## Memo

From: Peter Foley	Email: peter.foley@atkinsglobal.com
Date: 28 January 2022	Phone: N/A
Ref: 5150924DG0102	cc: Design Team

Subject: Adamstown Block G Amendment - RFI response

**Figure 1 – Drop off / Pick up alternative options**

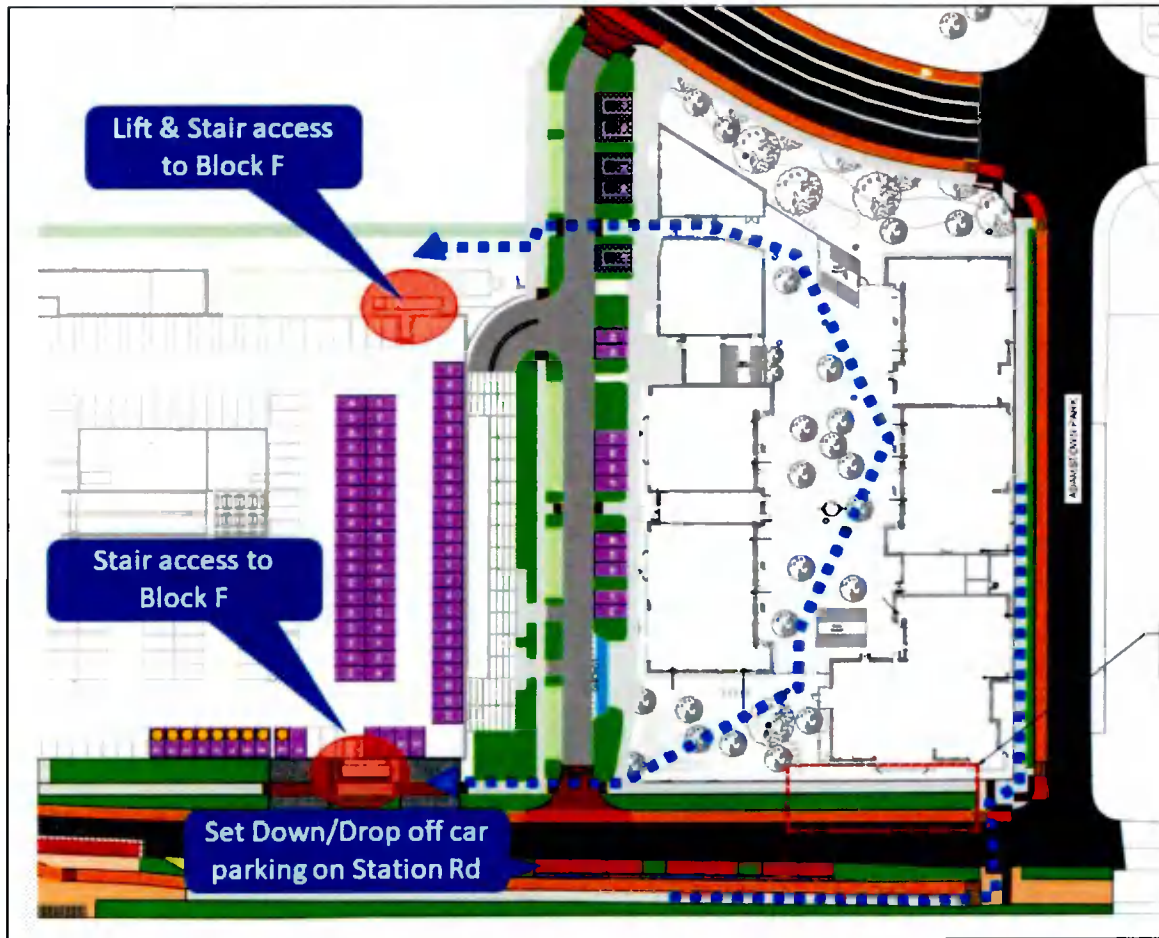
*(a) The principle of the design, with no car parking provided along the eastern avenue was permitted in the assessment of SDZ21A/0007 and predicated on the provision of on-site car parking. However, the current proposals provide for car parking off-site (located to the west of the site) with no provision for a set-down/drop-off for those living/accessing Block G2 from the east. The applicant is requested to consider a design solution to provide parallel parking/ a set-down/drop-off along the eastern avenue.*

In conjunction with other design team disciplines we examined an option(s) to introduce a set down drop off facility on the eastern side of Block G on Adamstown Park, however this was deemed unworkable as set out below.

It is important to note that residents in Block G2 will have access to and through the central courtyard and therefore will not require to walk around the block to access car parking in Block F. These routes shown in blue in Figure 1 are not excess for most people (less than 200metres).

In addition, there are alternative dedicated set down / drop off bays provided on Station Road (red bays) that residents in Block G2 can use with a dedicated signalised crossing provided for on Station road Adamstown Park junction to facilitate easy crossing of the road. Also subject to what Traffic Regulation orders are put in place on Adamstown Park drop off /set down could be allowed to occur for short periods of time on this road to facilitate this activity for a short period of time.

Some of the details above are shown in Figure 1 below.

**Table 1 - Previous Planning History detailing road cross section**

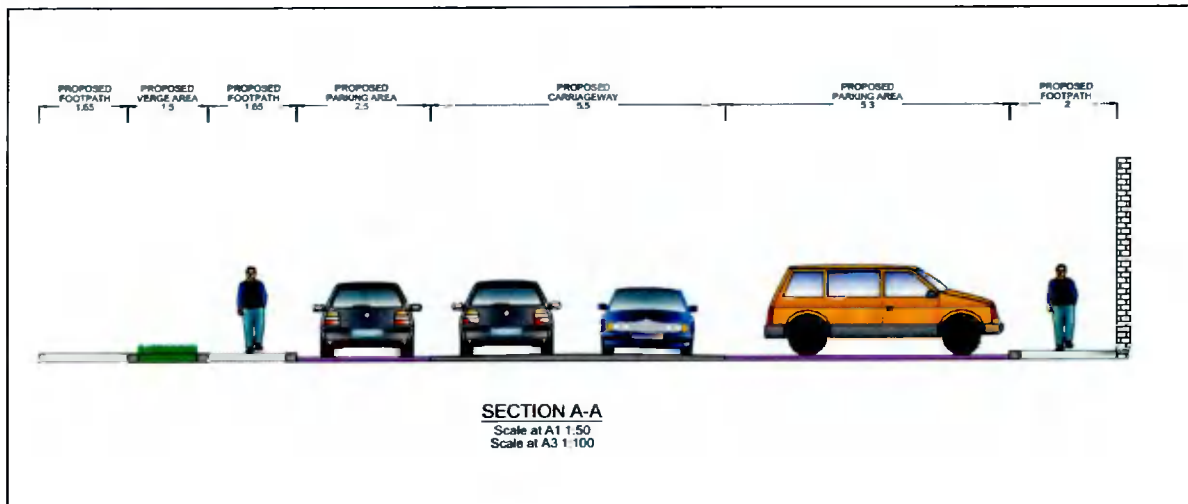
*The applicant is requested to clarify the above issue, submitting a detailed cross section, and demonstrating compliance with DMURS so that a full assessment can be carried out.*

The dimensions of north south road running between blocks F and G is as per the previous permission As shown in Table 1, including permission SDZ21A/007.

**Figure 4: comparison between current and previous treatment to meet east-west desire line.**

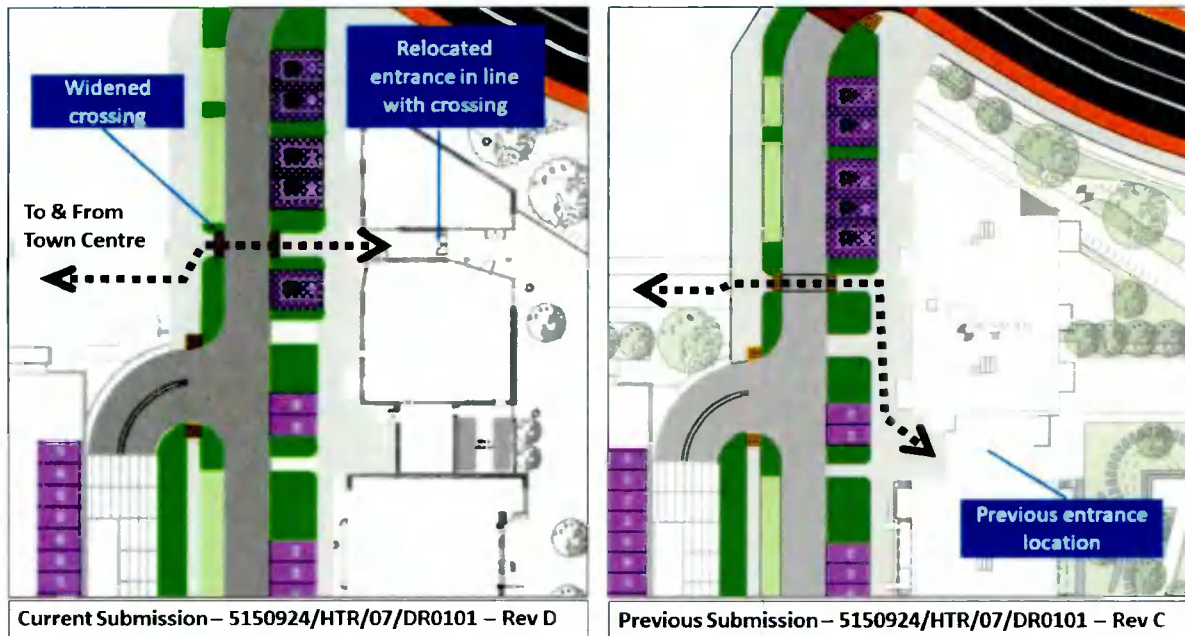
*The ground floor layout for the entirety of the Block G tile has been amended substantially. The under-podium car parking has been relocated to an 'off-site' location. An east-west pedestrian access is proposed through Block G1 via an indistinguishable façade, (narrow and located alongside a waste facility). This link will have alongside a waste facility). This link will have the important and crucial role acting as the primary link between the relocated car parking proposed in Block F and the heart of the Tile G (Blocks G1 and G2). The Planning Authority has reservations about this aspect of the proposal. This development will look westward for all its functions and needs. Therefore, any proposed east-west link should be expected to clearly demonstrate a safe, highly functional, well overlooked and comfortable pathway for all users in a westerly direction and be highly legible; it is not considered that this is achieved in the current proposals.*

In response to the above RFI item the Design Team have undertaken revision to the ground floor layout from the planning submission to:

- Main Entrance relocated northwards to line up with east-west desire line to and from the Town Centre between Block F and Quadrant H
- Widened crossing facility
- Repositioning of on-street car parking to facilitate the above

An extract showing the changes and comparison with previous design are shown in Figure 4.

The proposed changes provide greater legibility, safety, functionality, and comfort to this important east-west link in line with the RFI request.
